PRIVATE PLAN CHANGE 40 AGENDA – VOLUME 1

CLAYDEN ROAD, WARKWORTH

Hearing Report for Proposed Plan Change 40: (Warkworth – Clayden Road) to the Auckland Unitary Plan (Operative in part)

File No: Hearing Report – Proposed Private Plan Change 40 (PPC40)

Figure 7: Location of PC40 open space compared with WSP envisaged location of open space (open space locations indicated by red bubbles)

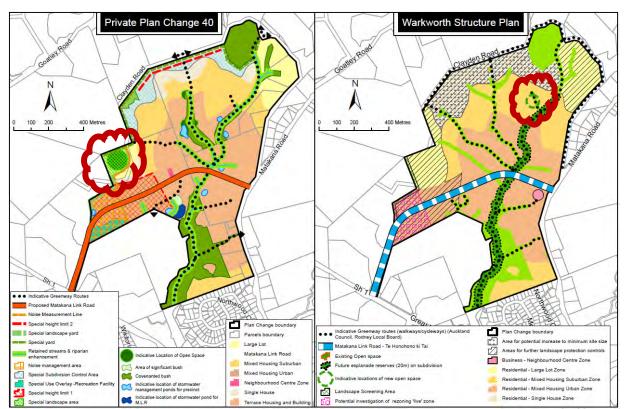
- 154. Mr. Munro considers that the location of the proposed open space is appropriate and efficient given the higher density proposed for the western side of the area. Locating the main open space area here allows more people to be within close distance of the open space. Refer to Figure 7 below for the proposed location of open space in PPC40, in contrast with that proposed by the Warkworth Structure Plan.

- 155. For the greenways Mr. Munro assesses that whilst it is preferred that the road layout allows streets to abut the greenway network and riparian margins where possible, in the case of this site, the topography makes this challenging. This is achievable in some areas, but not all.

Figure 12: Precinct Plan 1 (updated plan change 27 Aug) showing locations of various reverse sensitivity measures

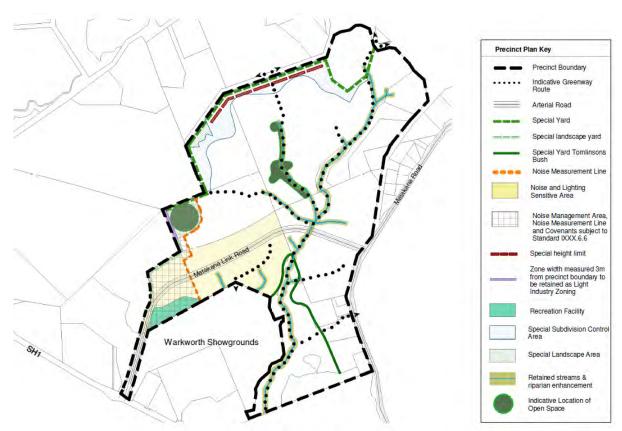
- 245. Mr. Brown considered the special landscape yard proposed at the interface between the adjacent LIZ and proposed plan change (refer to **Figure 10 and Figure 12** above). He considers it a positive measure, and that it would help to some extent in reducing the effects of light industrial development on neighbouring residential sites. He does note that the stated requirement of planting fifty percent of the special landscape yard is not clear in how it would be interpreted and implemented.

- 249. Mr. Qiu further notes that even with a 30m landscaped yard, (in line with the 20-30m yard proposed by the WSP), reverse sensitivity effects and residential amenity effects may still not be adequately mitigated. He does note that it is difficult to assess currently, without knowing the noise level and location of noise sources on the adjacent industrial land.

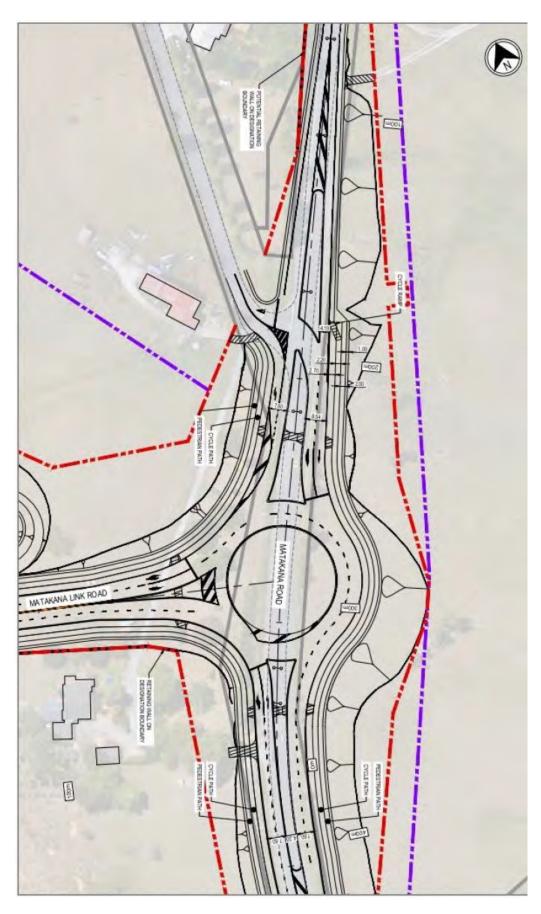
The masterplan shows two Cul de Sacs meeting the MLR but not connecting to it.

This is an ideal location for a Greenways Link as it leads to the proposed pool, the A&P sports grounds and on to the Park and Ride Transport Interchange to the south. It also serves as an off road route to the industrial area to the north.

Figure 4. Noise Contours over PPC 40

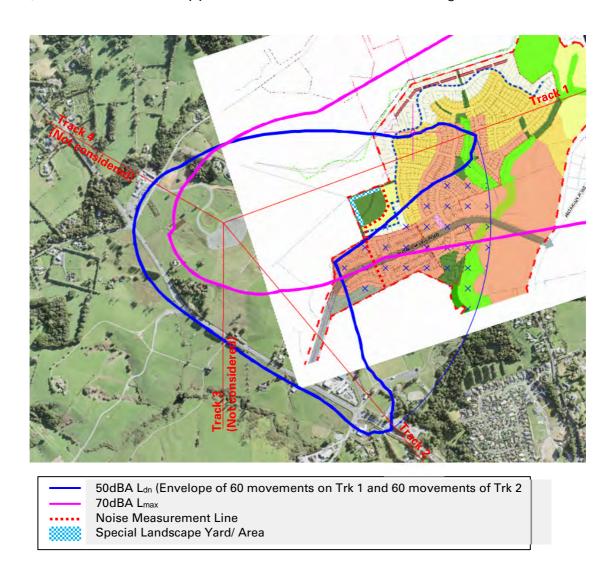
- Noise from helicopters continuing on Track 2 once they arrive at the PPC 40 boundary will exceed 50dBA L_{dn} over a small part of PPC 40;
- 3. Once the helicopters are at 1,000 feet, which will occur prior to PPC 40, they are free to turn to a course of their choosing. As such, it would be possible for the lobe of the contours to fall anywhere between those of Track 1 and Track 2. Considering all possible tracks within this range would result in an envelope of the 50dBA Ldn contour as described by the crossed hatching on Figure 4;

- 4. Noise from helicopters continuing on Track 1 once they arrive at the PPC 40 boundary will exceed 70dBA L_{max} over the majority of PPC 40; and
- 5. Should, having reached 1,000 feet, a single helicopter deviates from Track 1 in a southerly direction, Figure 4 shows that it would be possible to exceed the 70dBA L_{max} limit of the resource consent at any point within PPC 40.

Figure 4 shows that the permitted level of movements to and from Skywork has the potential to result in levels of noise at 50dBA L_{dn} or above over an estimated 50% of PPC 40. While such levels are generally accepted to result in adverse effects, it is noted that these levels would only occur in situations where Skywork placed a majority of their movements on a single track that passes over PPC 40. No work has been undertaken to determine how probable this is noting that such work would be limited in its accuracy due to the inherent difficulties in predicting future use. Further, should some of those flights be night flights, they would be counted as 10 day time flights. By way of example, three night flights would account for half of the daily allowance of 60 movements.

While the effects described using the L_{dn} metric are related to the number of movements, those associated with the L_{max} metric are the result of a single flight. Figure 4 therefore shows that any flight passing over PPC 40 would result in such levels as to produce an adverse effect.

The location of the noise measurement line is shown on Figure 4 above. The purpose of this line is not apparent as, without a noise limit referenced to it, it is unclear as to how it would contribute to any future consent application by Skywork. If it is intended that the 50dBA L_{dn} limit of the AUP applies at this line, Figure 4 indicates that this would likely have a significant effect on any future Skywork's consent application as, rather than offer flexibility it would require a reduction in the currently permitted movements over PPC 40. It should be noted that Figure 4 cannot be used directly to assess the noise from Skywork over PPC 40, as it includes helicopters after they have passed through 1,000 feet, and should therefore be excluded from the analysis. However, Figure 4 provides a strong indication that the 50dBA L_{dn} contour from the currently permitted movements would extend well past the Noise Measurement Line.

The Special Landscape Yard is identified on Figure 4. While its size is not defined, it appears too small to be of significance.

In terms of the extent of this closed window requirement, Figure 4 and the subsequent discussion, shows that levels of 70dBA L_{max} or greater can be expected over PPC 40 in its entirety meaning the closed window requirement should do the same.

Figure 4. Noise Contours over PPC 40

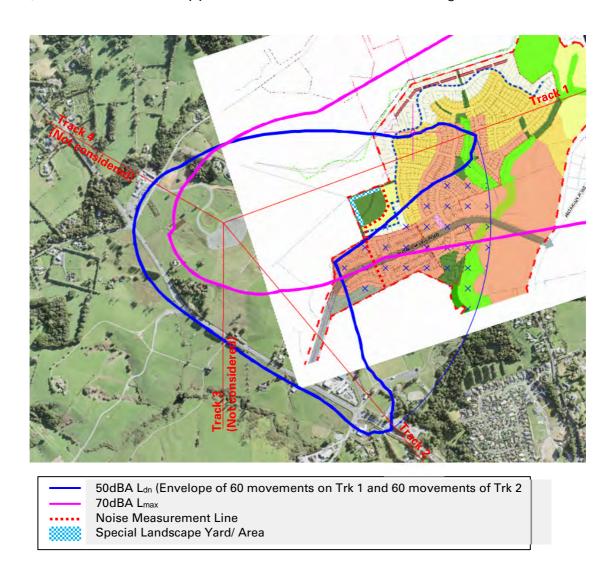
- Noise from helicopters continuing on Track 2 once they arrive at the PPC 40 boundary will exceed 50dBA L_{dn} over a small part of PPC 40;
- 3. Once the helicopters are at 1,000 feet, which will occur prior to PPC 40, they are free to turn to a course of their choosing. As such, it would be possible for the lobe of the contours to fall anywhere between those of Track 1 and Track 2. Considering all possible tracks within this range would result in an envelope of the 50dBA Ldn contour as described by the crossed hatching on Figure 4;

- 4. Noise from helicopters continuing on Track 1 once they arrive at the PPC 40 boundary will exceed 70dBA L_{max} over the majority of PPC 40; and
- 5. Should, having reached 1,000 feet, a single helicopter deviates from Track 1 in a southerly direction, Figure 4 shows that it would be possible to exceed the 70dBA L_{max} limit of the resource consent at any point within PPC 40.

Figure 4 shows that the permitted level of movements to and from Skywork has the potential to result in levels of noise at 50dBA L_{dn} or above over an estimated 50% of PPC 40. While such levels are generally accepted to result in adverse effects, it is noted that these levels would only occur in situations where Skywork placed a majority of their movements on a single track that passes over PPC 40. No work has been undertaken to determine how probable this is noting that such work would be limited in its accuracy due to the inherent difficulties in predicting future use. Further, should some of those flights be night flights, they would be counted as 10 day time flights. By way of example, three night flights would account for half of the daily allowance of 60 movements.

While the effects described using the L_{dn} metric are related to the number of movements, those associated with the L_{max} metric are the result of a single flight. Figure 4 therefore shows that any flight passing over PPC 40 would result in such levels as to produce an adverse effect.

The location of the noise measurement line is shown on Figure 4 above. The purpose of this line is not apparent as, without a noise limit referenced to it, it is unclear as to how it would contribute to any future consent application by Skywork. If it is intended that the 50dBA L_{dn} limit of the AUP applies at this line, Figure 4 indicates that this would likely have a significant effect on any future Skywork's consent application as, rather than offer flexibility it would require a reduction in the currently permitted movements over PPC 40. It should be noted that Figure 4 cannot be used directly to assess the noise from Skywork over PPC 40, as it includes helicopters after they have passed through 1,000 feet, and should therefore be excluded from the analysis. However, Figure 4 provides a strong indication that the 50dBA L_{dn} contour from the currently permitted movements would extend well past the Noise Measurement Line.

The Special Landscape Yard is identified on Figure 4. While its size is not defined, it appears too small to be of significance.

In terms of the extent of this closed window requirement, Figure 4 and the subsequent discussion, shows that levels of 70dBA L_{max} or greater can be expected over PPC 40 in its entirety meaning the closed window requirement should do the same.
